ACCESSION NBR:8007080140 DOC.DATE: 80/06/30 NOTARIZED: NO DOCKET #
 FACIL:50-250 Turkey Point Plant, Unit 3, Florida Power and Light C 05000250
 AUTH.NAME AUTHOR AFFILIATION
 UHRIG,R.E. Florida Power & Light Co.
 RECIP.NAME RECIPIENT AFFILIATION
 EISENHUT,D.G. Division of Licensing

SUBJECT: Requests permission to delay scheduled shutdown for steam generator insp until 801006. Delay needed to accomodate peak load demand for Jul-Aug 1980. Updated generating capacity & expected load demand info & class III fee encl.

Re: Turkey Point Unit 3
Docket No. 50-250
Steam Generator Inspection

ATTACHMENT TO LICENSE AMENDMENTS

Figure 3.2-3b

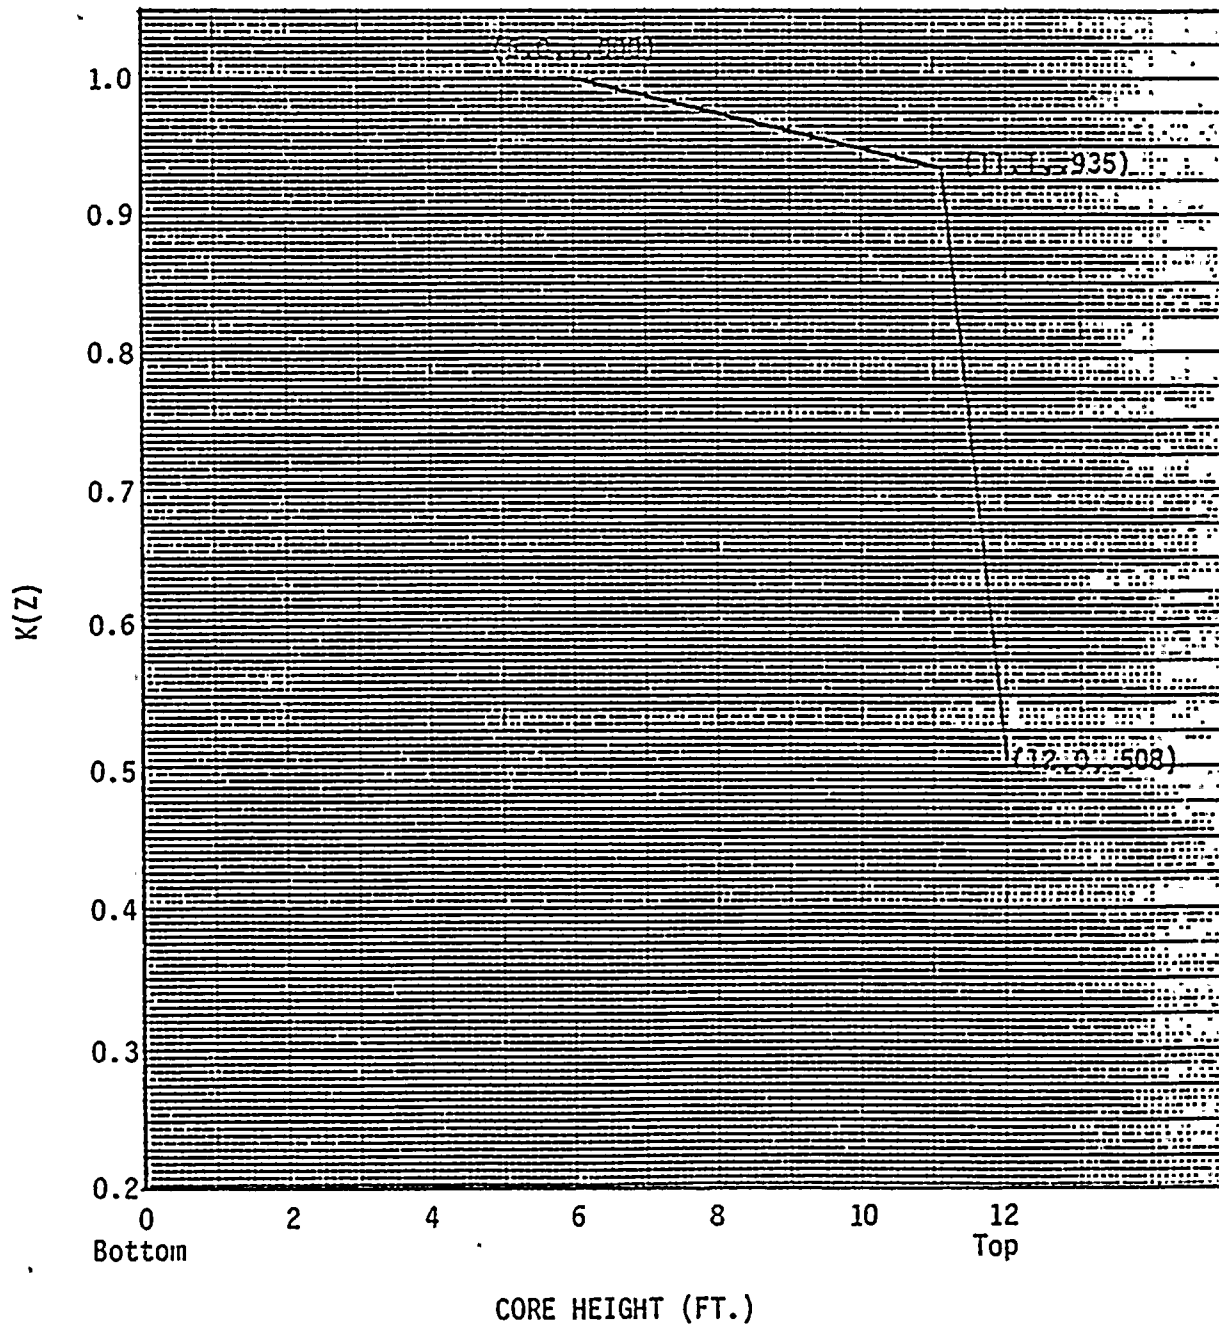
Where P is the fraction of rated power at which the core is operating; K(Z) is the function given in Figure 3.2-3b; Z is the core height location of F_q .

- (a) Specification of $F_Q = 1.97$ for plant operation with 25 percent of steam generator tubes plugged.
- (b) Change of the Hot Channel Factor Normalized Operating Envelope for a steam generator tube plugging level of 25 percent (Figure 3.2-3b)

- (1) With steam generator tube plugging $\geq 22\%$ and $\leq 25\%$, the hot channel factors (defined in the basis) must meet the following limits at all times except during low power physics tests:

$$F_q(Z) \leq (1.97/P) \times K(Z), \text{ for } P > .5$$

$$F_q(Z) \leq (3.94) \times K(Z), \text{ for } P \leq .5$$

$$F_{\Delta H}^N \leq 1.55 [1.0 + 0.2 (1-P)]$$
